PLANNING COMMISSION STAFF REPORT

Korean Presbyterian Church of Utah Conditional Use & Planned Development

425 East 700 South

Petitions PLNPCM2010-00231 and
PLNSUB2010-00422

NORTH
 DEVELOPMENT SITE PLAN
 SCALE : 1" = 10'-0"

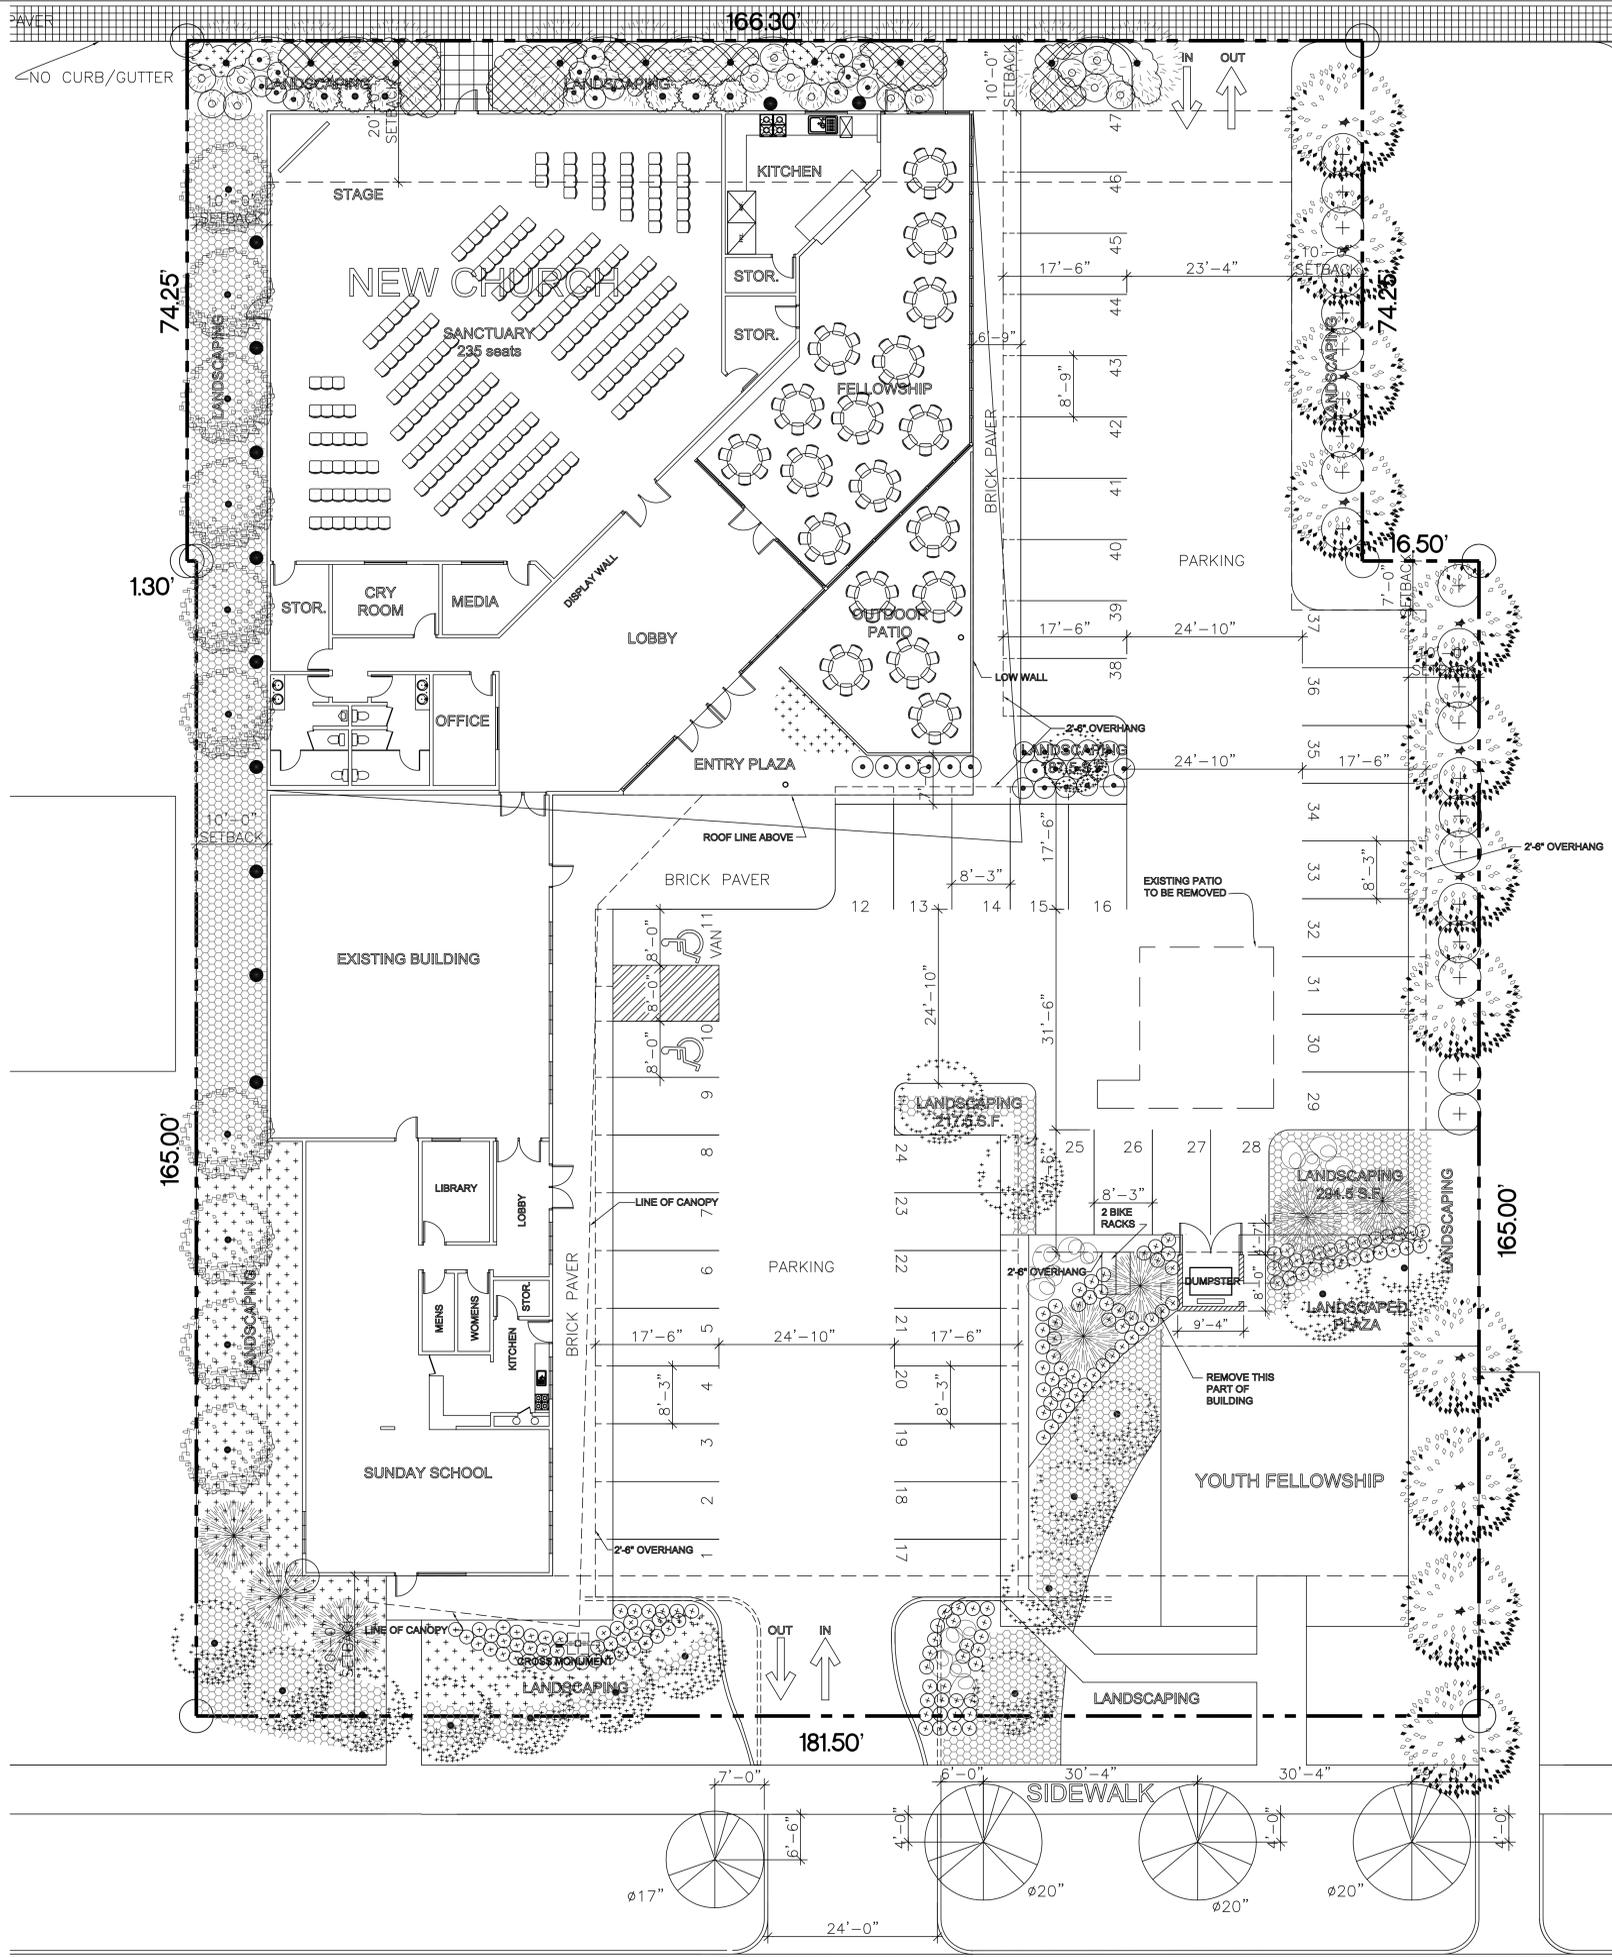
Per our DRT review 2/11/2010 the site needed to combine all lots. The ADA van stall needs to be 8' wide with a 8' wide off loading area. The parking calculations (Standard SLC stalls 8'-3" to 9'-0", No compact designation) need to indicate the required 5% bike stall provision and indicate locations and detail per SLC standard F1.f2. New driveways are to be per APWA standards with 5' plus off set from trees, poles or fire hydrants etc. The dumpster location needs to be moved south to allow for the 2'-6" overhang or full 17.5' deep stall for #27 & #28.

- 1) The conditional use PUD is proposed to address modifications to the building and parking setbacks on Segoe Avenue. However, a proposed canopy and required parking also encroach into the 20 feet front yard setback along 700 South and will need to be address through the conditional use process as well.

- 2) The parking calculations on the site plan reference 14 compact parking stalls which cannot be recognized as meeting the required parking demand under the current zoning ordinance. Parking stalls #40 through 47 entering from Segoe Avenue do not meet the minimum 24 feet 10 inches required for back out. As a remedy the abutting landscape area can be reduced to 7 feet measured from property line to the back of curb to meet the required back out and still be in compliance with Table 21A.44.050 (parking in required yards) and section 21A.48.070.C (perimeter parking lot landscaping).

- 3) Parking stalls #27 and 28 located in front dumpster cannot be considered as meeting the required parking count because they do not meet the minimum 17.5 dimensional requirement and are in conflict with trash removal and back out from parking stall #29.

- 4) The copy of the site plan that has been provided has been reduced in size and is no longer to scale making it impossible to verify the fixed dimensional standards or numerical minimum / maximum conditions which govern site development. However, it appears that the interior parking lot landscaping does not meet the minimum 5% requirement. Parking lot

landscaping located within 20 feet of the front property lines along Sego Avenue and 700 South are to be counted towards perimeter parking lot landscaping. Areas counted toward interior parking lot landscaping must be located on the interior of the parking lot, or located adjacent to the parking lot and more than 20 feet from a property line.

NORTH ELEVATION
 SCALE : 1/8" = 1'-0"

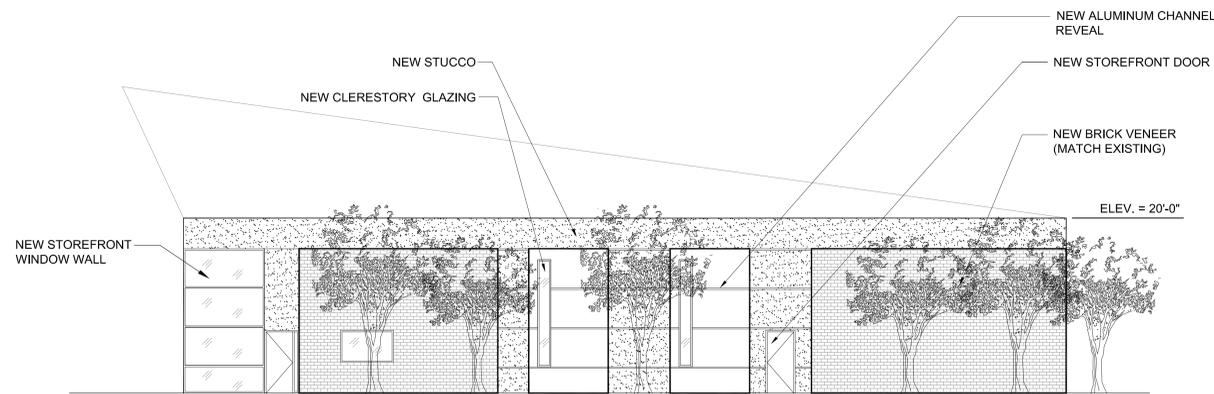
Finding: The main wall that is located along Sego Avenue has a mixture of surfaces that should be sufficiently varied to appear interesting to any pedestrians. Because the proposed use is a church and not a commercial/retail building, there is limited opportunity for public spaces and display areas.

Finding: The height limit in the RMF-35 zoning district is 35 feet, but the building at Segoe Avenue is only 20 feet, equivalent to many of the homes along the street. The building is at its highest in the interior of the block.

- Front yard and one interior side yard landscaping as per 21A.48.090
- 6) No elevation plans have been provided to show compliance with the maximum height of structure which shall not exceed 35 feet or 3½ stories, whichever is less.

- 7) No elevation plans have been provided to show compliance with front façade controls as per 21A.21.010.I along Sego Avenue and 700 South.
- 8) Parking lots open for use during hours of darkness, 1 hour after sunset, shall be provided with lights and lighting facilities as per 18.80.070. Lights shall be located, directed or designed in such a manner so as not to create glare on adjacent properties as per 21A.24.010.K.
